Submission regarding

SESOC Practice Note: Design of Conventional Structural Systems Following the Canterbury Earthquakes

Ref: 12999-01

March 2012

Figure 1: Relationship between R factor and return period for New Zealand locations m (from NZS 1170.5 2004)

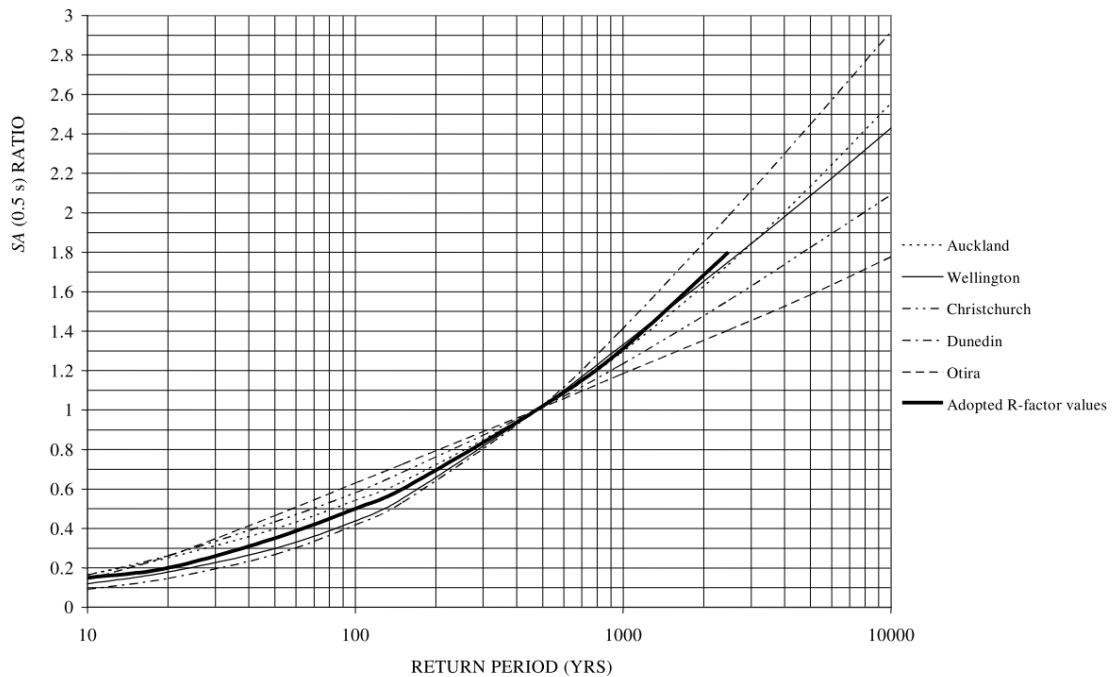
Compusoft Engineering Limited considers that this section is currently quite unclear. If we understand it correctly, the implication is that the MCE level earthquake should differ depending on the importance level of a structure, for example that for an IL4 structure the MCE level actions should be $1.8 \times 1.5 \times$ “ULS actions for an IL2 structure”, where the 1.8 factors relates to the return period factor, “R”, and the 1.5 factor relates to the margin of the MCE actions being “at least 1.5 to 1.8 times the ULS level”.

If the understanding above is correct, Compusoft Engineering Limited believes that this is an unnecessarily and unrealistically severe requirement. While it is not realistic to place a precise figure on the likelihood of such actions, we note that a multiplier of $1.8 \times 1.5 = 2.7$ on the 500 year/ULS earthquake actions is likely to equate to a return period of the order of 12000 years. This value has been obtained based on curve fitting to the “average” return period factor used in the New Zealand Design Actions Standard (NZS 1170.5 2004). It is worth considering that for many areas of New Zealand a multiplier of 2.7 on 500 year actions would result in an even longer return period, as can be extrapolated from Figure 1, which has been taken from the commentary of the Design Actions Standard.
